# THE RETREAT AT WOLF CREEK CONDOMINIUMS

## CONSTRUCTION DOCUMENTS EDEN, WEBER , UTAH

THE RETREAT AT WOLF CREEK CONDOMINIUMS  
CONSTRUCTION DOCUMENTS

PLAN AND PROFILE SEWER 3

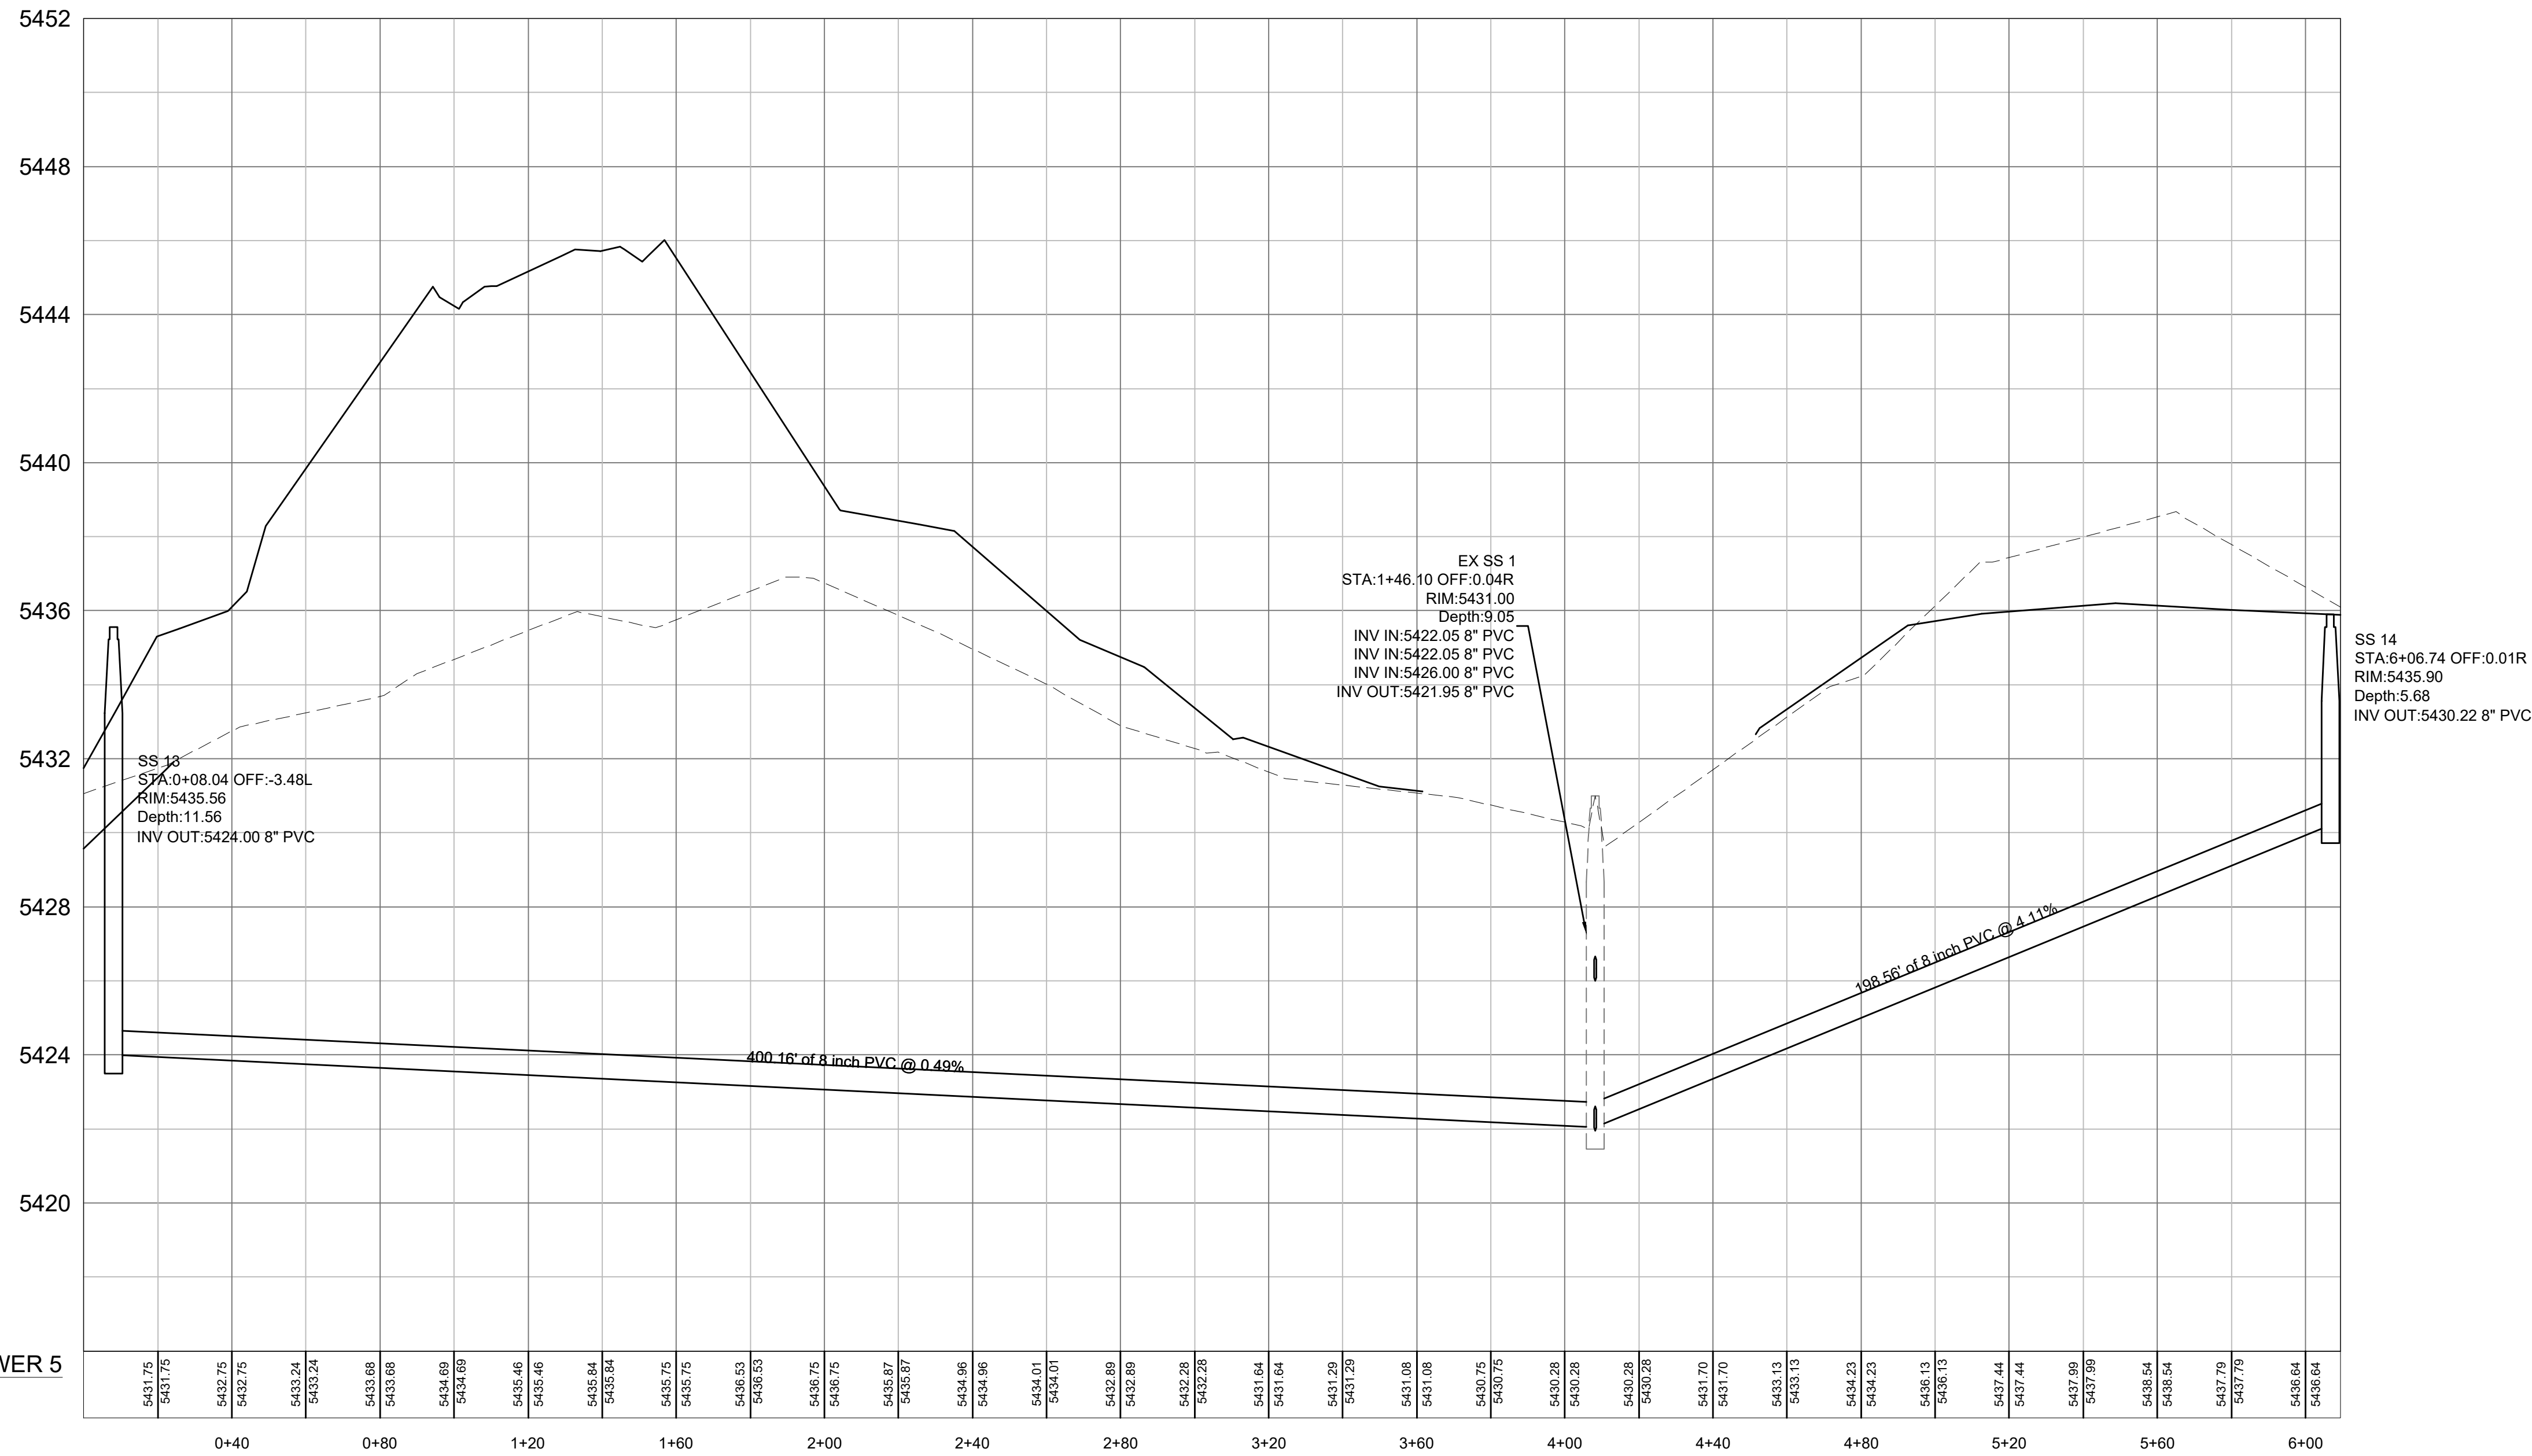
Check with the water and sewer company to make sure they are OK with this location.

PLAN AND PROFILE PONDS  
 THE RETREAT AT WOLF CREEK CONDOMINIUMS  
 RETREAT DR  
 EDEN, WEBER, UTAH

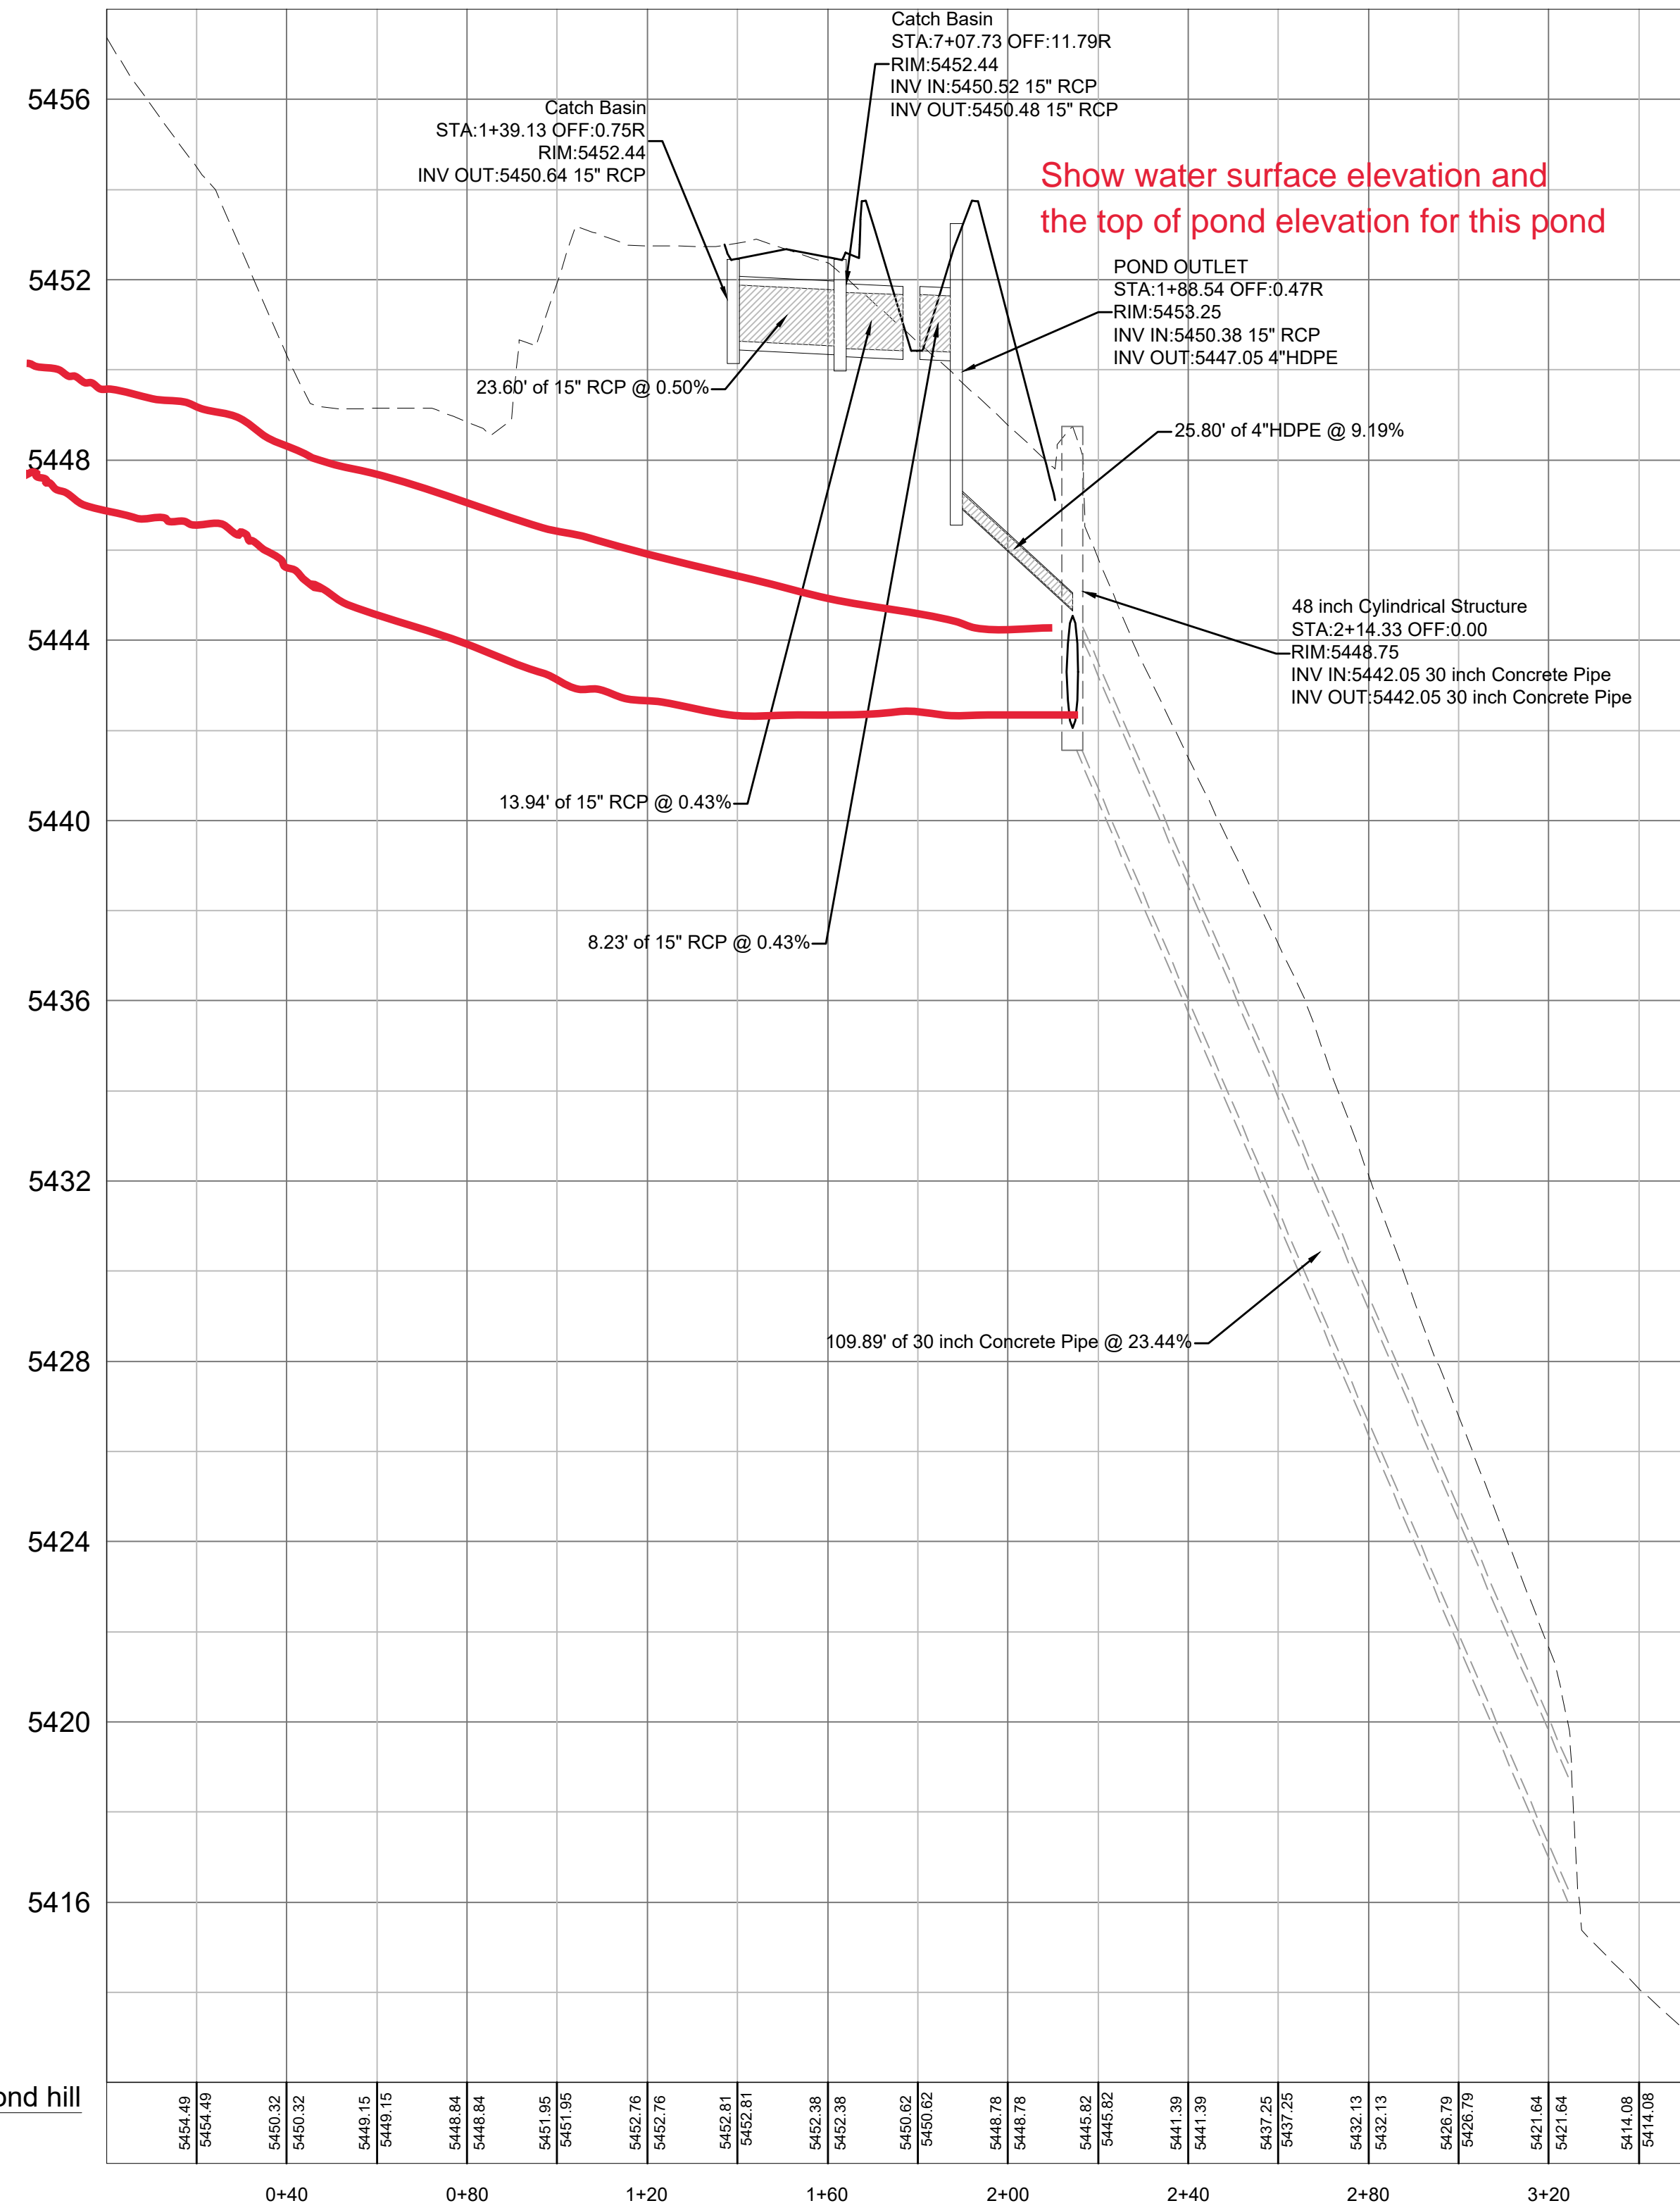
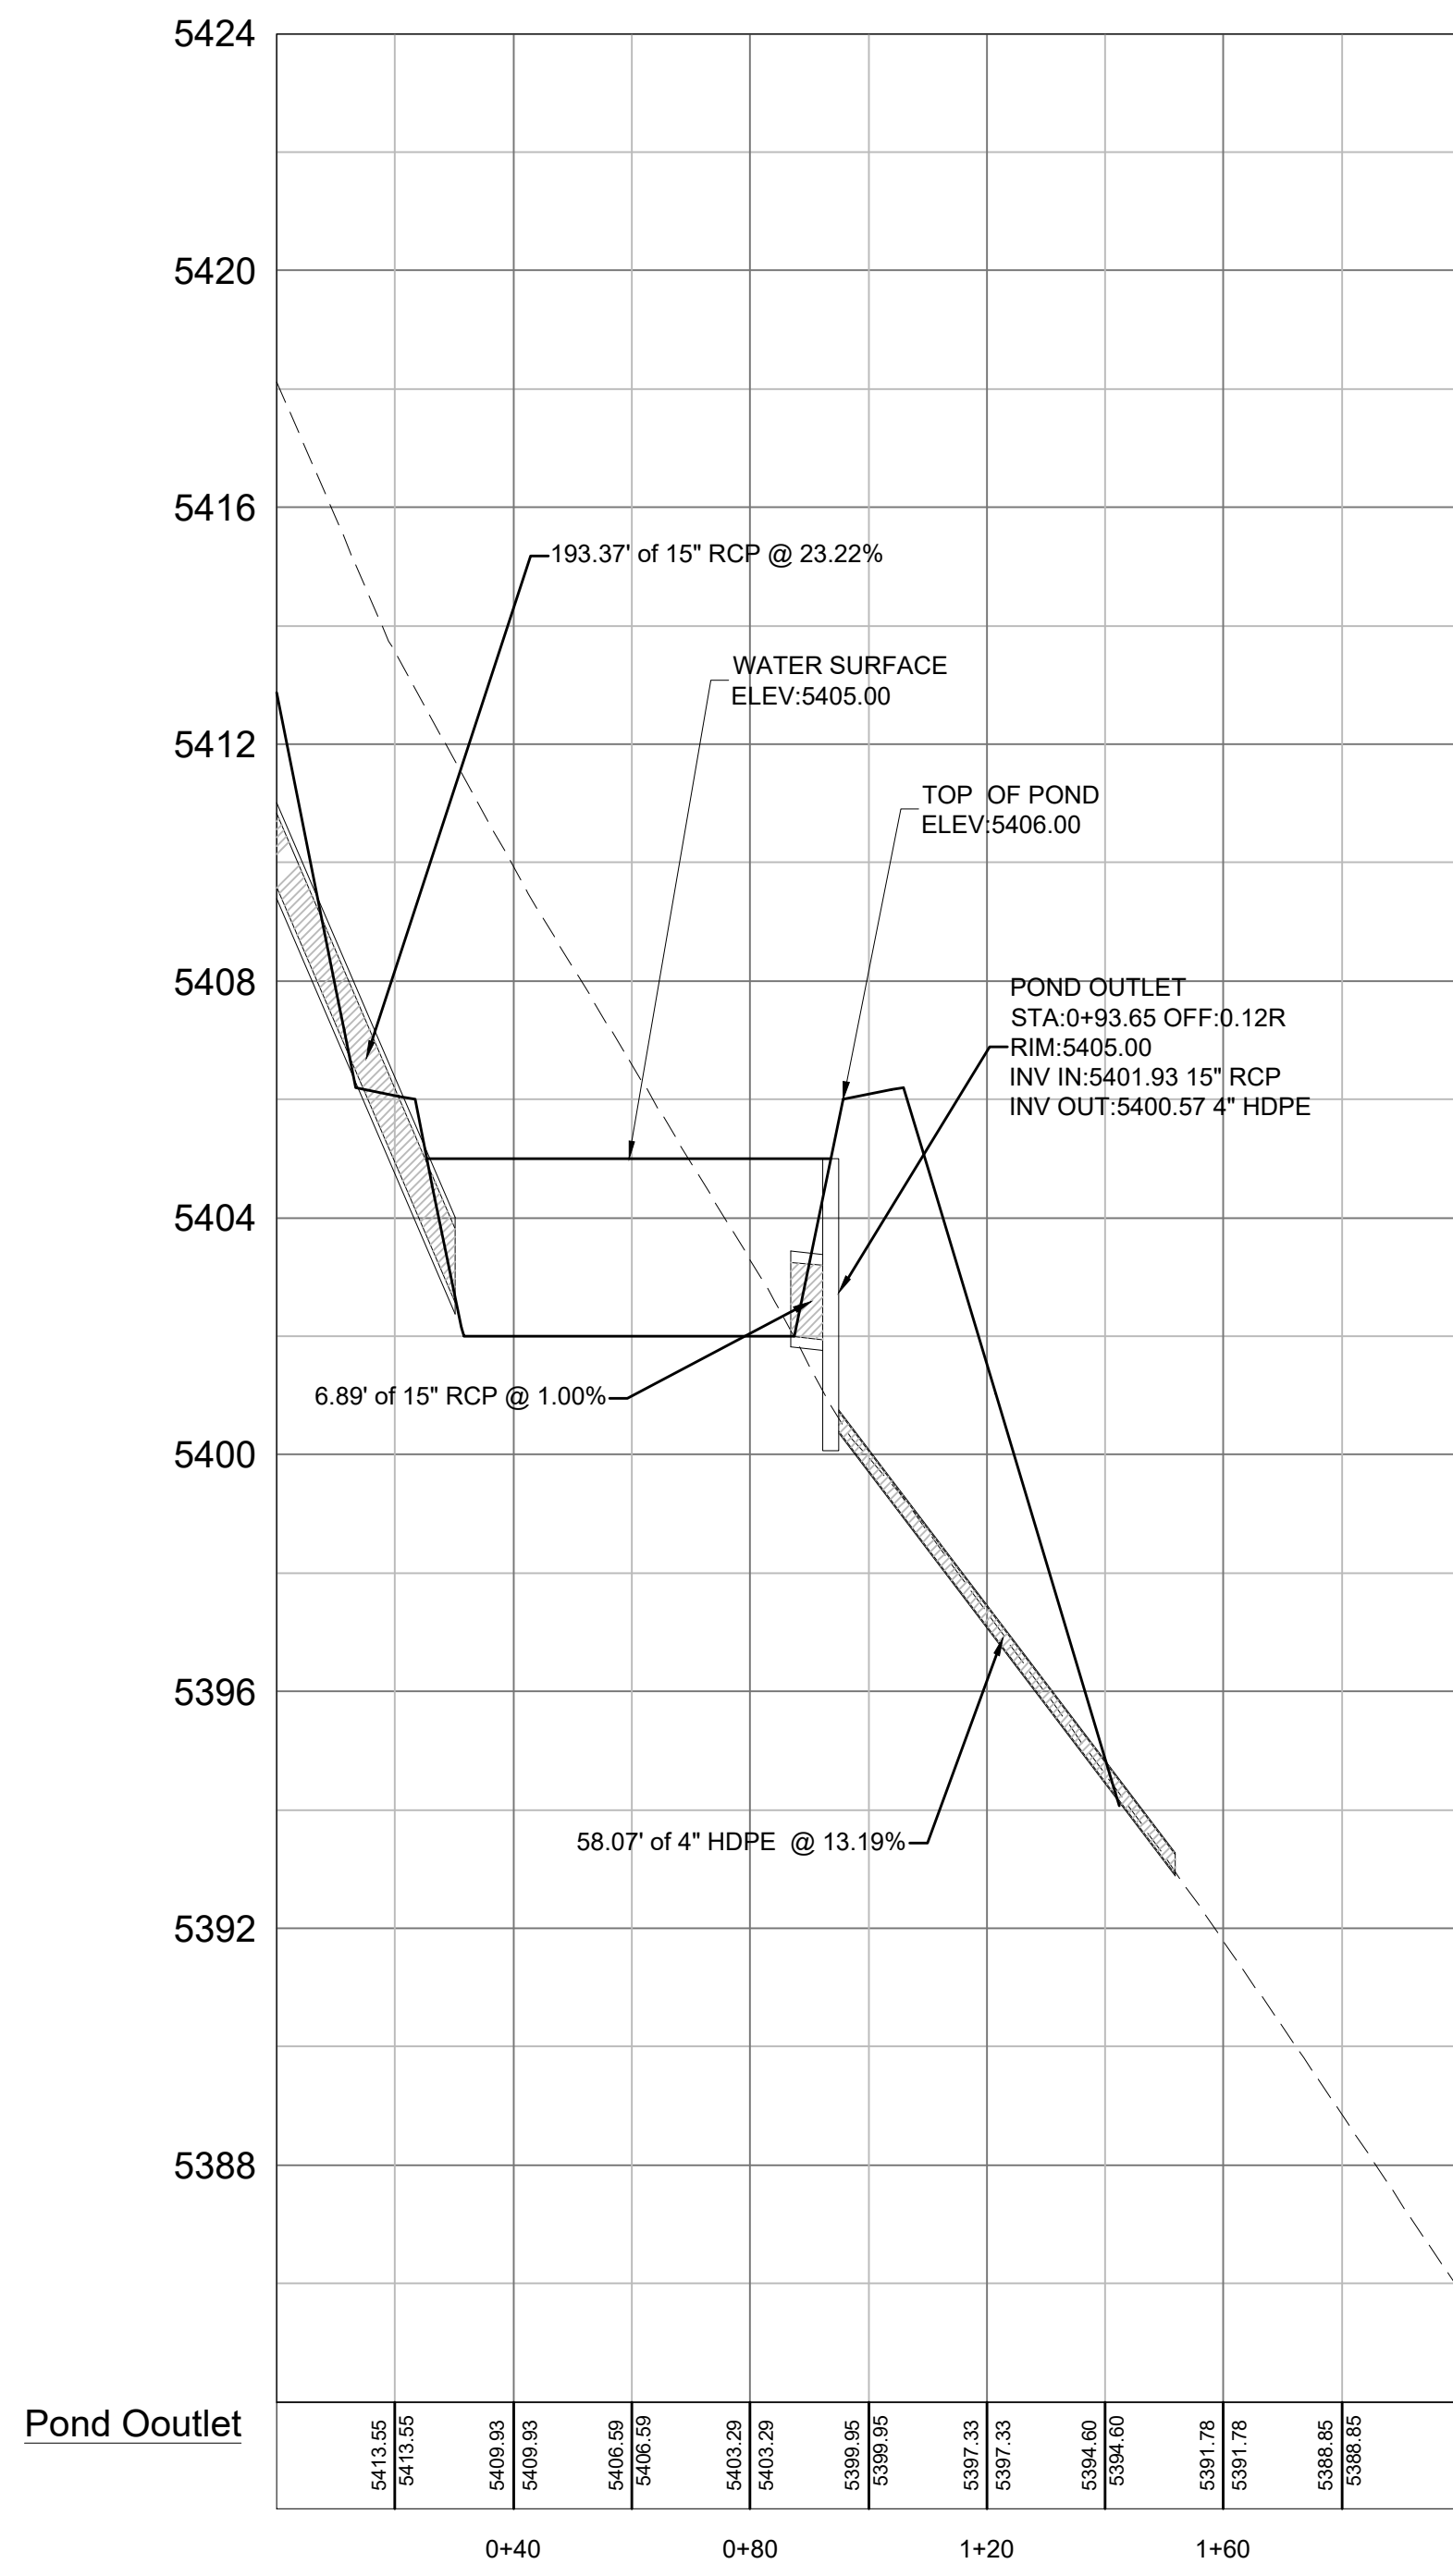
Can you show the elevation of the 30" storm drain line coming from existing pond?

cross section ex pond hill
